TRANSMITTAL

Work Changes Proposal Request No. 1 Revised

13117 Lexington Replacement Fire Station No. 2

Change Order #1

Attachments: C-102, C-201

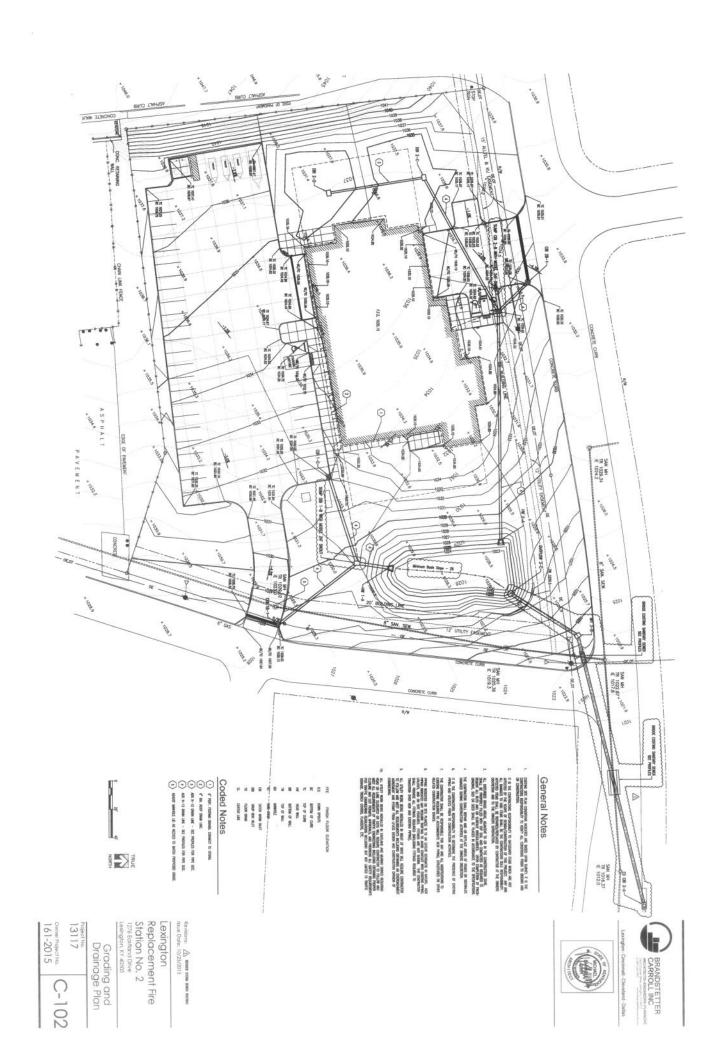
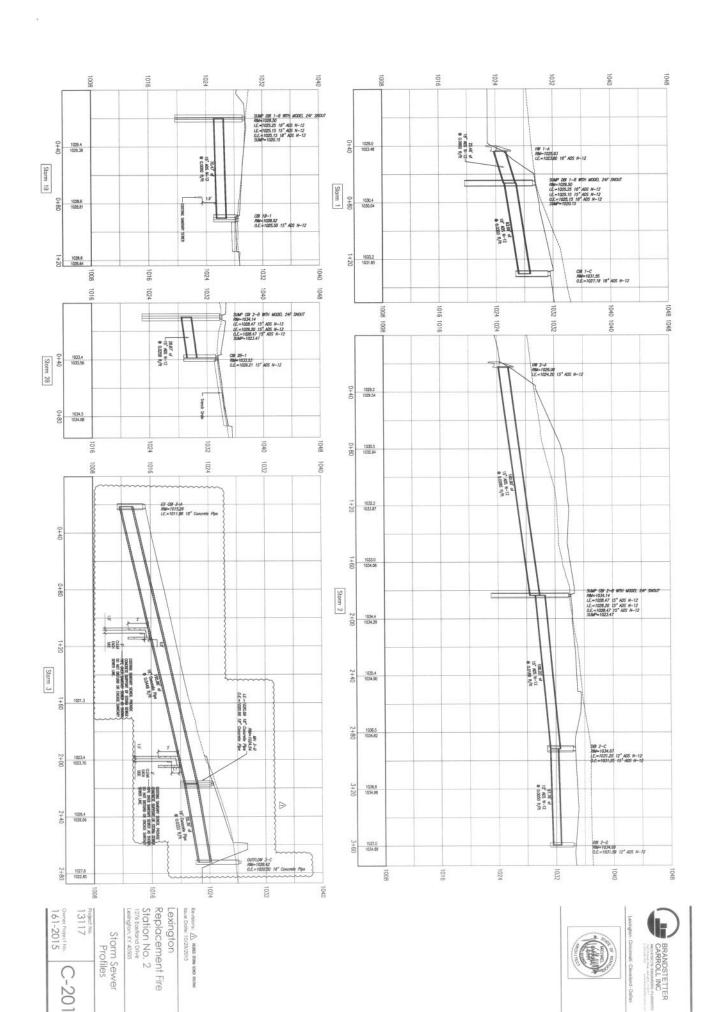
- 1. Per the City review and inability to gain an easement from adjacent property owner, Provide itemized pricing to modify storm sewer as shown in the attached updated sheets C-102 Grading and Drainage Plan and C-201 Profiles.
- Per contractor request in RFI 2, please submit credit pricing to use the following piping for sanitary piping below slab and on the exterior for City to review for consideration.
 - SDR 11 piping in lieu of heavy duty cast iron piping for all exterior sanitary sewer piping
 - Schedule 40 PVC piping in lieu of Cast Iron piping below slab.
- 3. Per City request, please submit itemized pricing to add CMU base course(s) to Patio Footing on East side to bring even with patio slab and adjacent grade as discussed at the Progress Meeting on 3/31/16.
